*MEMORANDUM*

TO: ISC  
 FROM: Daniel Sigg  
 SUBJECT: Phase Frequency Discriminator Modifications  
 Refer to: LIGO-E1700100-v1

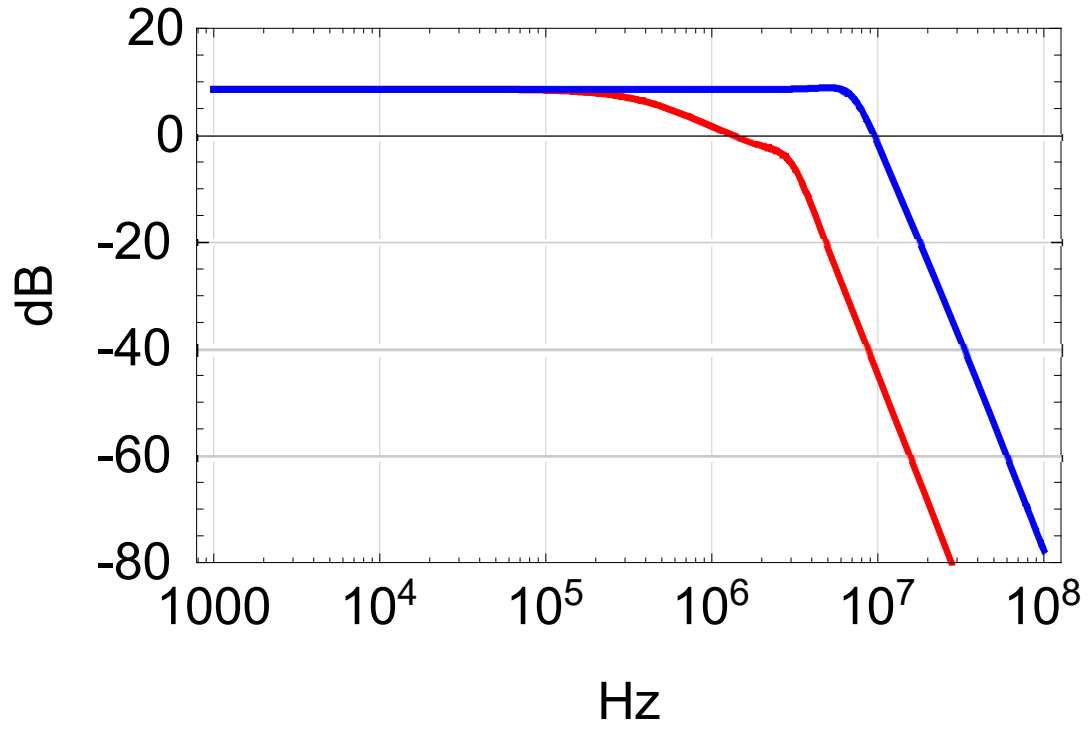
The table-top frequency stabilization servo (TTFSS) is using the phase frequency discriminator (PFD) for laser locking. The standard circuit board variant has a bandwidth of no more than 500 kHz. For laser locking an overall bandwidth around 1 MHz is desirable and we require the PFD to introduce no more than 20° of phase at 1 MHz. The schematics can be found under [D1002471](#).

Parameters	Standard	High Frequency	Unit
Pole frequency (Q)	0.46 3.0 (1.5) 3.0 (1.5) 5.3	5.7 7.1 (1.4) 7.1 (1.4) 17	MHz
Phase at 0.1 0.5 1.0 2.0 MHz	-15 -59 -90 -135	-2 -10 -19 -38	°
3-dB bandwidth	0.48	7.7	MHz
Capacitor C15	150	47	pF
Capacitor C16	1000	47	pF
Capacitors C26 & C43	15	4.7	pF
